SUB-PHASE AMENDMENT 1 YERBA BUENA ISLAND SUB-PHASES 1YA & 1YB

MARCH 26, 2019

PREPARED FOR TREASURE ISLAND DEVELOPMENT AUTHORITY

This amendment is the presentation by TICD of additional detailed information to update the Sub-phase Application 1: 1YA and 1YB approved in 2015. It includes plans, diagrams, data, and narrative that supersedes or adds information to the approved 2015 Sub-phase Application in compliance with the Project's Design Review and Document Approval Procedure (DRDAP) exhibit to the DDA.

FIGURE 3.1 PEDESTRIAN NETWORK SITE PLAN

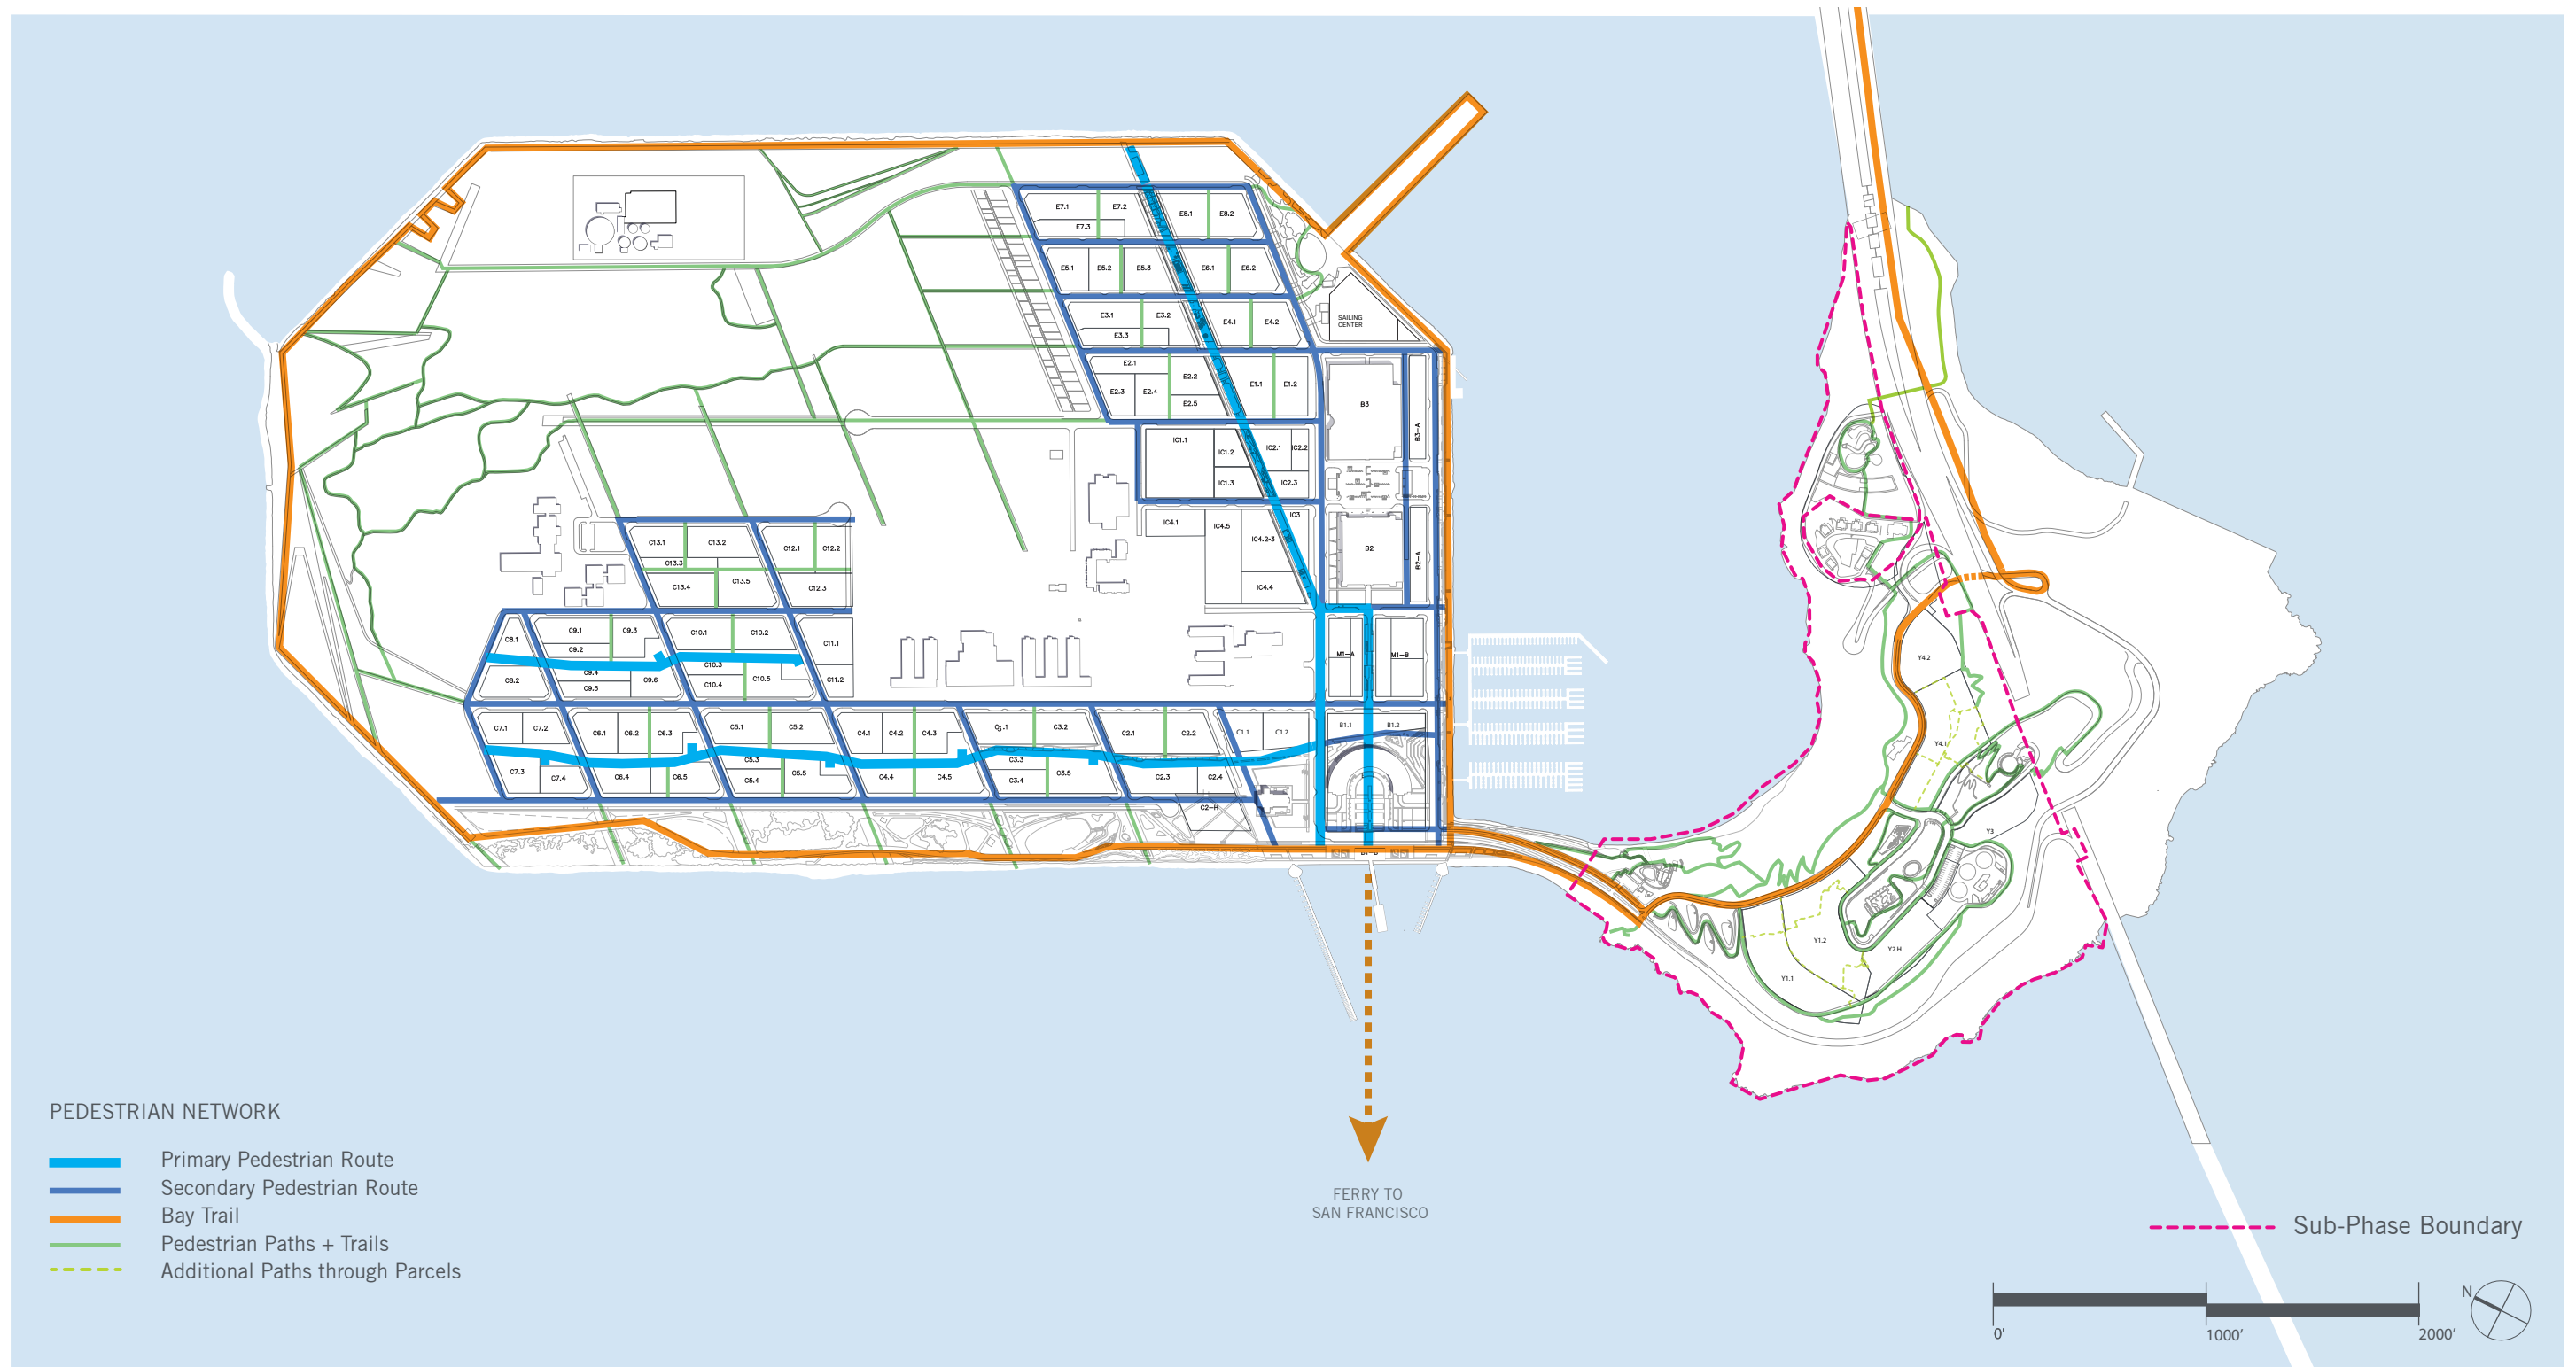
1. The overall pedestrian network has been updated to reflect the current pedestrian paths through the parks, the trails and habitat management areas and the anticipated paths through the development parcels.
2. The vehicular and transit network reflect updates to Signal Road between the 3Y Parcel and Hilltop Park 2. The road runs north of the parcel and now terminates in a roundabout sized to accommodate vehicles, the on-island shuttle, and EVA turnaround.
